INDIAN POINT NUCLEAR GENERATING PLANT UNIT NO. 2

CONSOLIDATED EDISON COMPANY OF NEW YORK, INC.

DOCKET NO. 50-247

APPENDIX XII-1

Fig. II-2
Indian Point Site

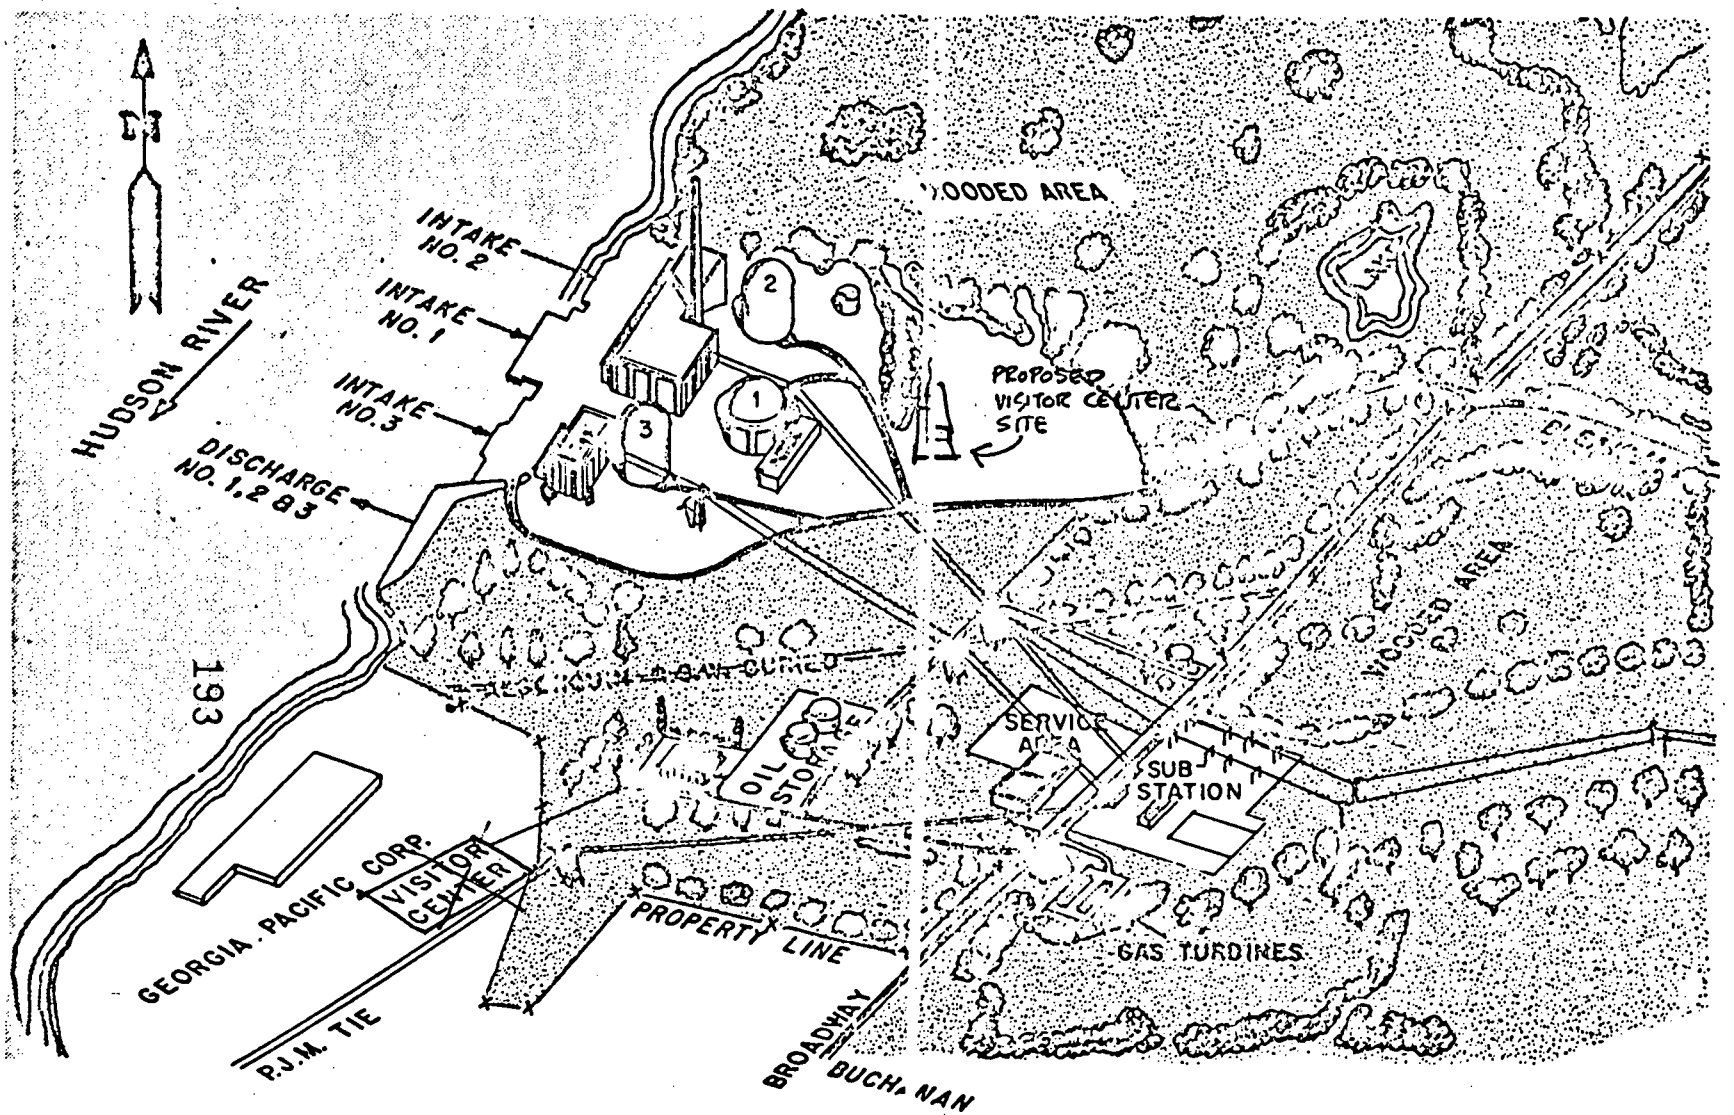
14. Page II-3, fig. II-2. :See attached figure for new location of Visitors' Center.

FIGURE 2

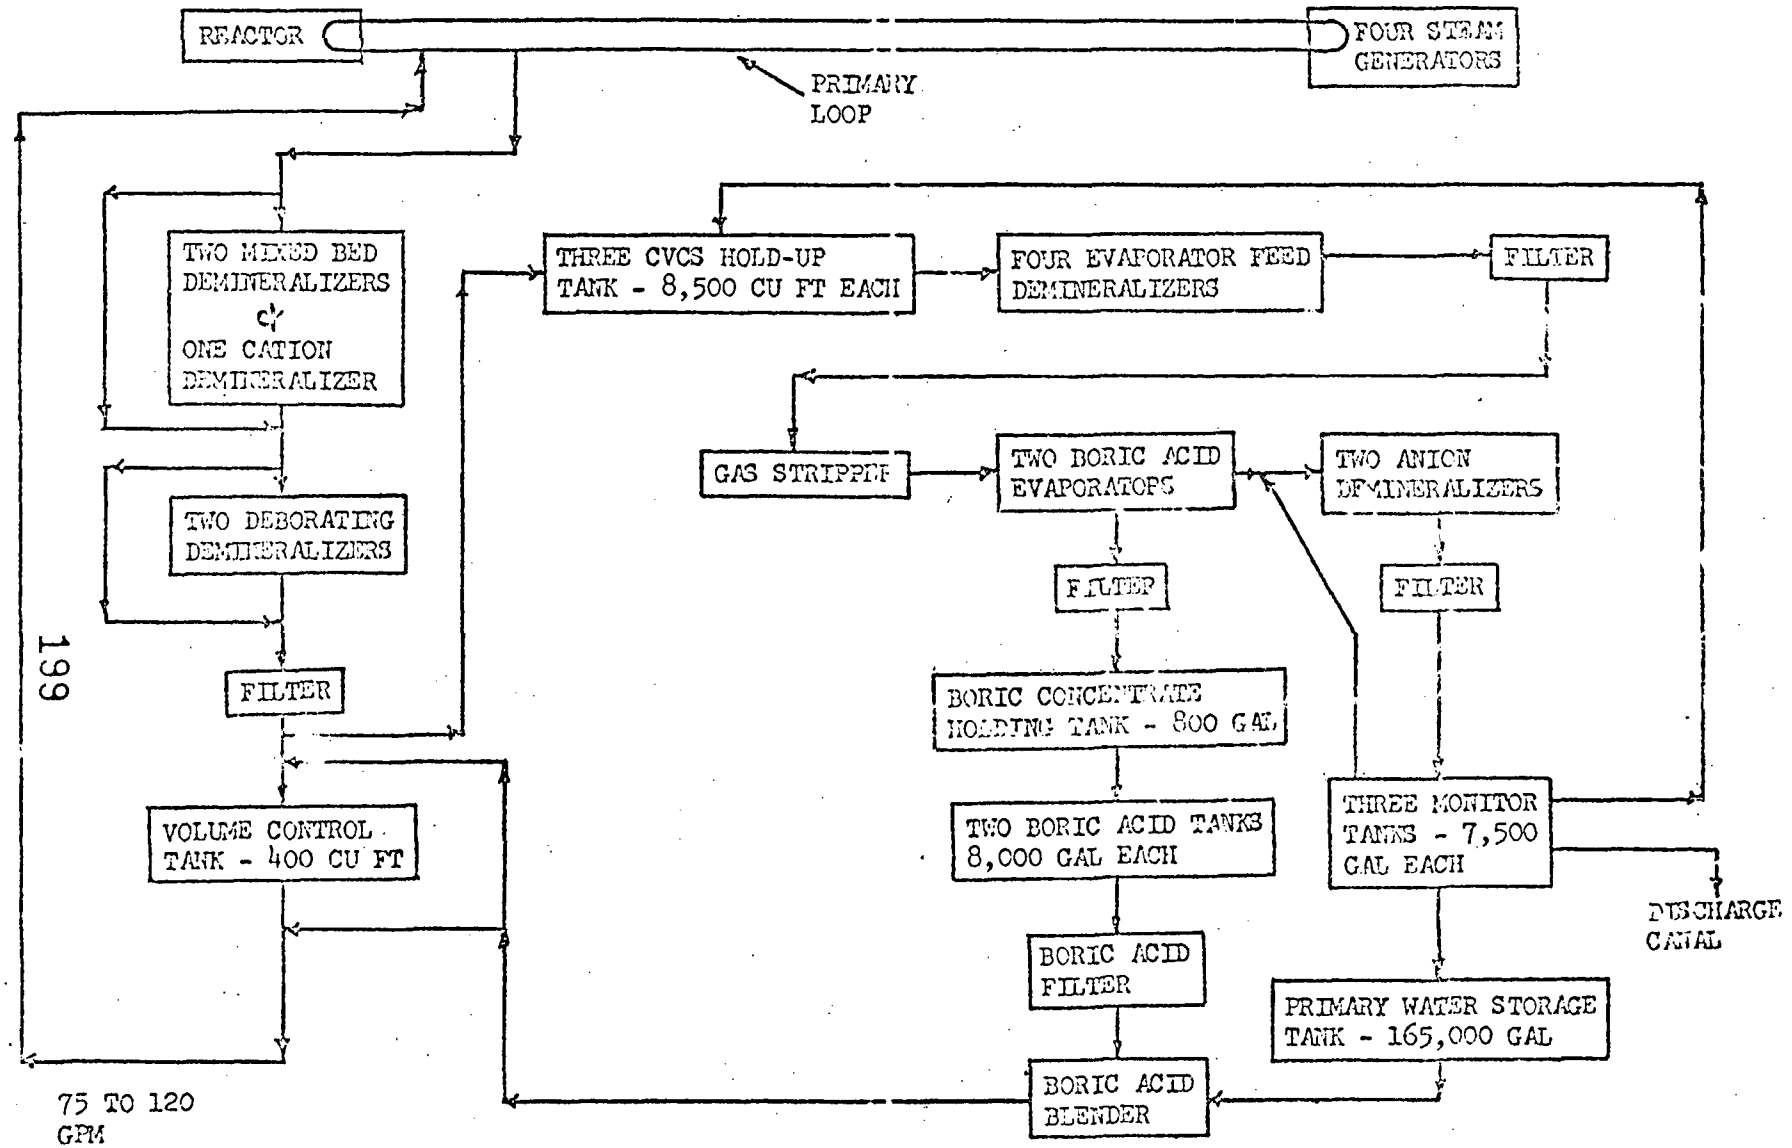
74.	Page III-41, Fig. III-13.	:See attached Figure (Figure 2) for more accurate description.
75.	Page III-42, First para., line 2.	:Two demineralizers are provided. Normally neither is used until toward the end-of-core life, then one or both may be used.

PRIMARY COOLANT PURIFICATION IN CHEMICAL AND VOLUME CONTROL SYSTEM - INDIAN POINT UNIT NO. 2
